Moldova Roads Rehabilitation V
NATIONAL ROAD ADMINISTRATION

CLARIFICATION DOCUMENT No.2

Rehabilitation of M1 – Leuseni - Chisinau Road:

(client's reference RSP/W16/01-02)

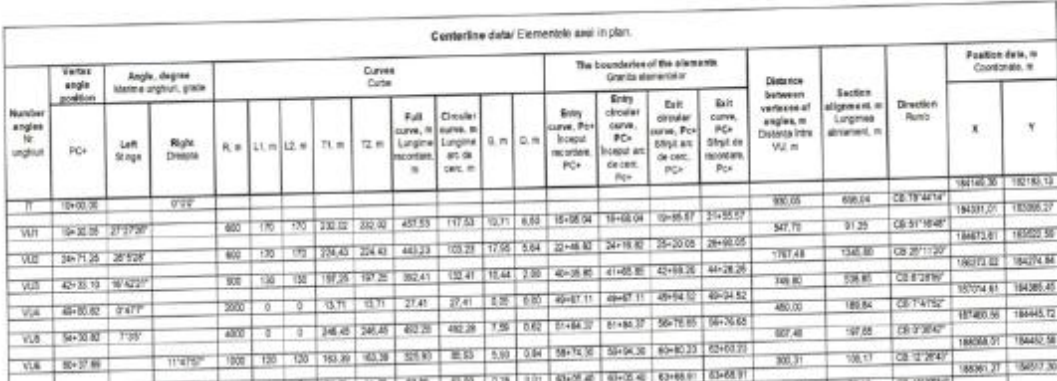
29.	Please clarify what the hatching shown in the detail below beneath the New Jersey barrier, between the longitudinal joints filled with sealant, refers to, considering that the Typical Cross-Section shows either a rigid F4.5 concrete pavement structure or a green area. Also, please confirm that the concrete surface execution solution can be adopted based on the equipment which will be used.	The hatching beneath/adjacent to the New Jersey barrier represents the cement-concrete pavement in the median barrier area, as indicated on the relevant pavement-joint drawing. The green median applies only where specifically shown as green area. Concrete paving may be executed using fixed forms or slipform equipment in accordance with Chapter 309 and the approved method statement.

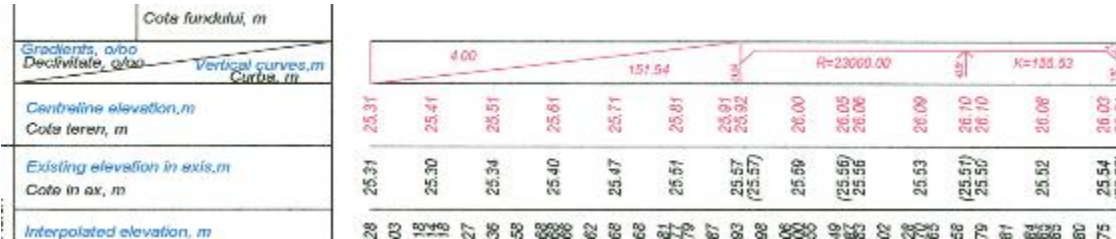
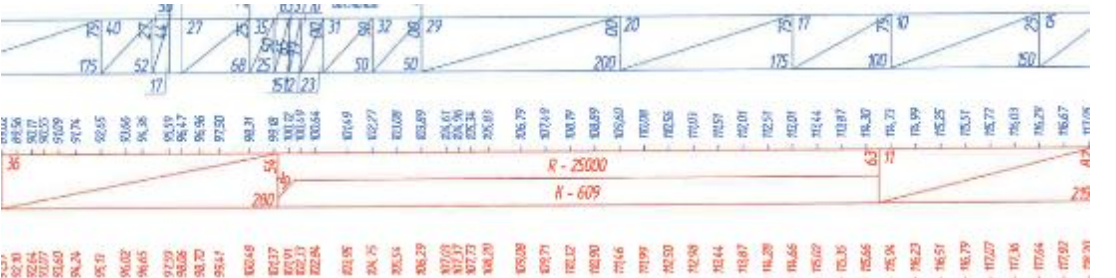
32.	We were unable to identify details relating to Item “50902 - Construction of filter subdrains” or Item “60403 - Pipe drain” (in accordance with the technical drawings). Please provide the relevant drawings or indicate the page of the Technical Design on which these details can be found.	Items 50902 – Construction of filter subdrains and 60403 – Pipe drain will be excluded from the Bills of Quantities.

The respective BoQs (for Lot 1 and Lot 2) are amended by Amendment nr 2 and appended to this Clarification #2
	With reference to Item 40105 - Removing of various reinforced concrete items of the superstructure for Bridge PC 83+32, please clarify the following: • how many girders the existing bridge comprises; • the location of the Employer's facility where the girders must be stored; • whether the crane hours under Item 40107A - Crane Working as work on manipulation and stock - lifting superstructure beams (60 t) include the hours required for storing the girders at the Employer's facility, or only the hours required to dismantle the girders from the existing bridge; • please also justify the use of the unit of measurement No. for the crane item, considering that such equipment is rented by operating hour or day of use.	Please refer to the Item 40105 that primarily covers the demolition of concrete sidewalks. The existing bridge comprises 20 superstructure girders to be removed. The Employer's storage location and the corresponding transport distance on average 50 km. Item 40107A is a payment item per handling/lifting operation at the construction site and at the storing facility (if necessary), the unit rate shall include crane time, mobilisation, rigging and labour. The unit is measured in number of precast items to be lifted, placed and/or displaced. The contractor shall determine the necessary time, mobilization, rigging and labor, etc. depending on the machinery and equipment owned or rented.

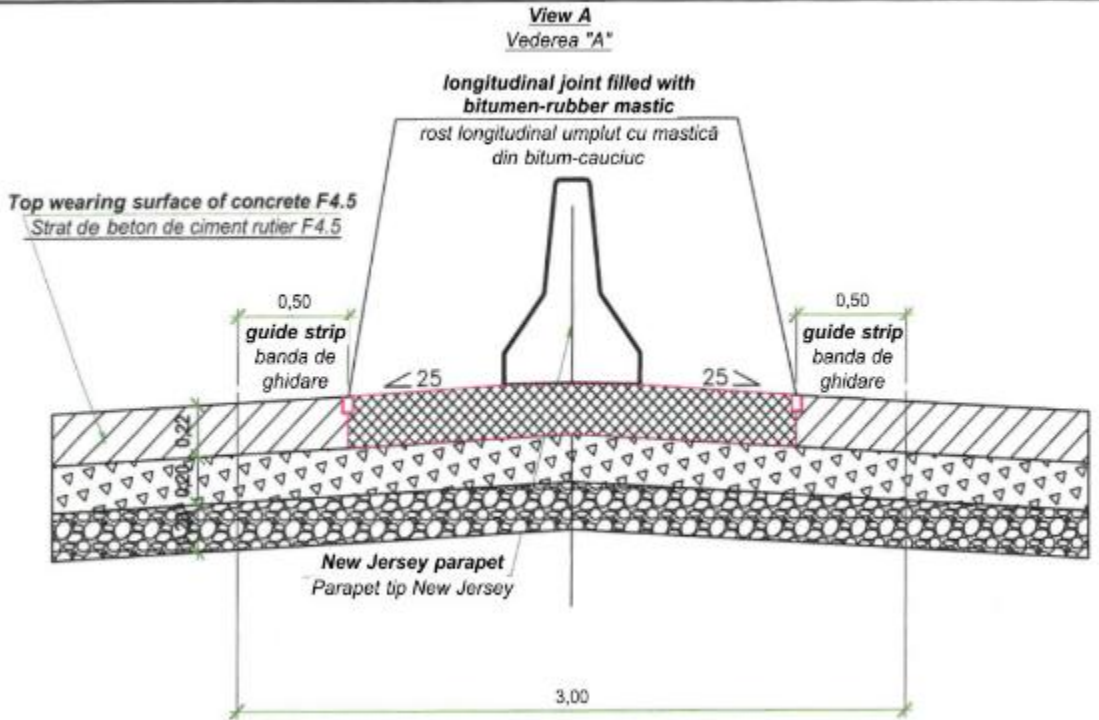
42.	Please confirm that the base width of the trapezoidal channel under Item 50302.3 is $b = 0.40$ m.		Please note that the Romanian description indicating 0.60 m is incorrect and is amended The correct base width for Item 50302.3 is $b = 0.40$ m.;

Item No.	Description	
	50302.3	Consolidation of trapezoidal channel Type 1, $b=0.4$, $h=0.5$ (1:1.5/1:1.5) / Consolidarea rigolelor trapezoidale de Tip 1 $b=0.6$, $h=0.5$ (1:1.5/1:1.5)	
	The English and Romanian descriptions indicate different base widths (0.40 m and 0.60 m respectively). Please confirm the dimension to be used for pricing and execution.

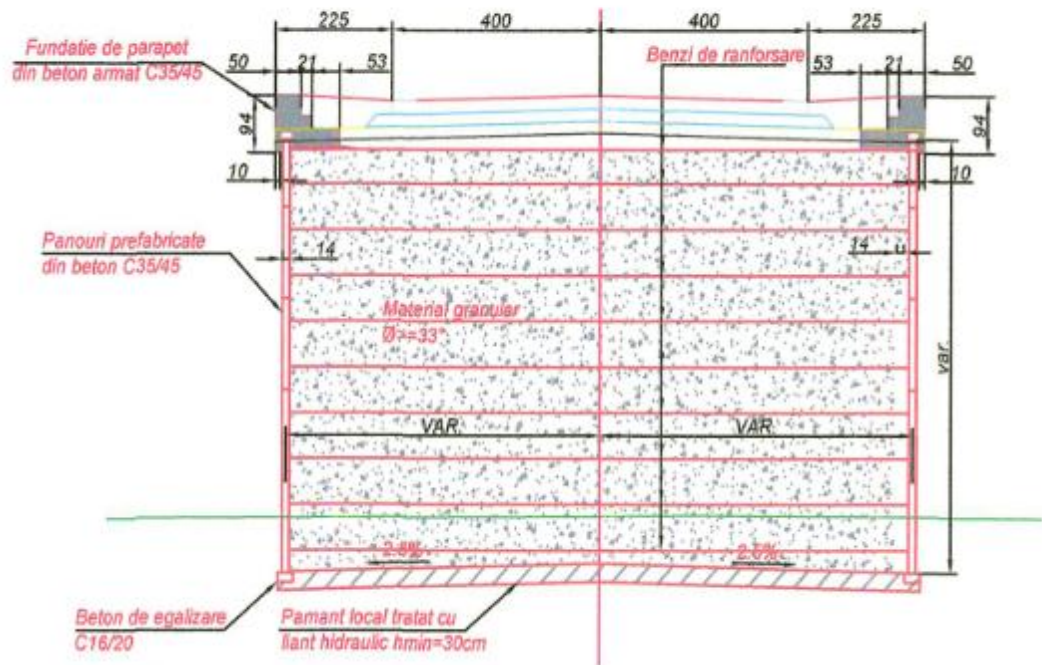
72.	For each existing culvert, detail drawings are provided which also include quantities relating to the component elements of the culvert, such as concrete, reinforcement, strengthening works and additional end protections. Please clarify the relationship between these quantities and the corresponding items in the general Bills of Quantities for the Contract.

In particular, we note that consolidation quantities are shown in the drawings, while separate items also exist in the BoQ, such as those illustrated below.

Under these circumstances, please specify:

- whether the quantities indicated in the culvert detail drawings are for information only or must be complied with by each Tenderer;
- whether the strengthening works and quantities shown in the culvert drawings are those to be priced under Items 50109.1 and 50109.2, or whether these items refer to other works distinct from those shown in the culvert drawings;
- whether the concrete pipe culvert extension works and quantities shown in the culvert drawings are those to be priced under Items 50107.1, 50107.2 and 50107.3, or whether these items refer to other works distinct from those shown in the culvert drawings.

According to the Construction Drawings each Tenderer must comply with these.

Items 50109.1 and 50109.2 include the quantities for the Additional protection works at inlets and outlets for all types of culverts.

Confirmed. The concrete pipe culvert extension works and the corresponding quantities shown in the culvert drawings are those to be priced under Items 50107.1, 50107.2 and 50107.3.

PROFIL TRANSVERSAL TIP

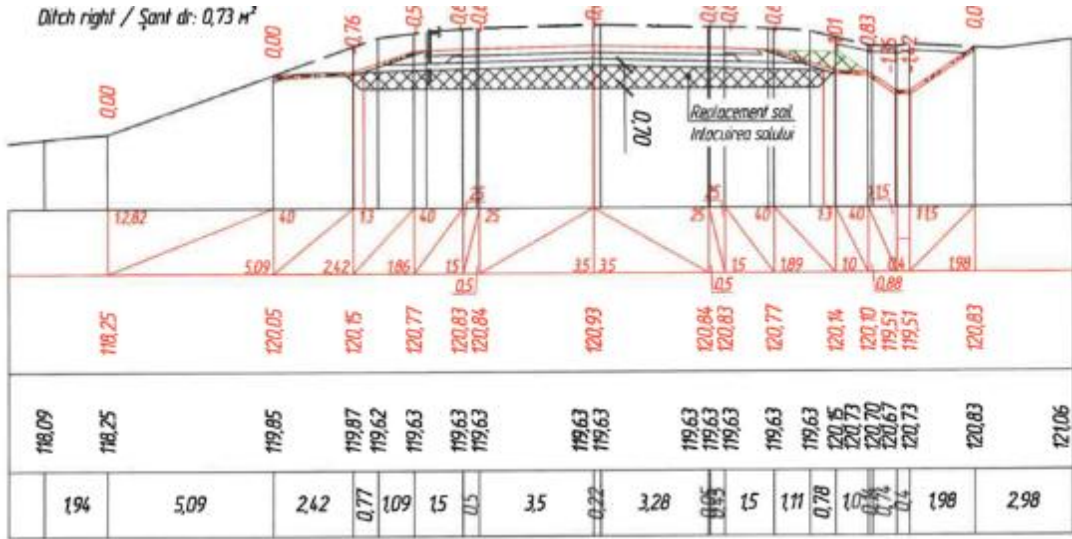
76.	With reference to the reinforced soil works shown in the typical cross-section:	The question refers to Lot 1 1. The C35/45 cast-in-place parapet foundation/concrete console is covered by the detailed quantity basis for the reinforced-soil retaining wall. The quantity basis provides 134,620 kg of B500 reinforcement for 612.70 m³ of C35/45 concrete, corresponding to an average reinforcement ratio of approximately 219.7 kg/m³ (≈220 kg/m³). The relevant reinforced-soil details are shown in Volume 2, Book 1, Drawings 171–174. 2. The granular fill forming the reinforced-soil mass shall be included under Item 90403 – “Fill material behind the modules (units)”, measured in m³, in accordance with

1. Considering that the attached drawing indicates a C35/45 reinforced concrete safety barrier foundation, while the documentation contains no reinforcement details, please specify the reinforcement ratio assumed by the Designer for this element.
2. The typical cross-section indicates a significant volume of granular material between the prefabricated facing panels of the reinforced soil system. Please explicitly specify under which item in the Bills of Quantities the quantity of granular material must be included.
3. The Bills of Quantities include Item 60401 - Construction of retaining wall in reinforced concrete (in accordance with the technical drawings), 13 m³. Please clarify what this quantity represents, as the documentation provided does not clearly indicate the structural element or the method used to determine this quantity.

Chapter 904 of the Technical Specifications and the relevant Drawings.

3. The 13.00 m³ under Item 60401 does not relate to the reinforced-soil wall shown in the attached typical section. It relates to the separate 12.0 m retaining wall at PC 80+74.00, shown in Volume 2, Book 1, Drawing 17. The detailed quantity basis provides 13.00 m³ of cast-in-place C30/37 XF4 concrete for this wall.
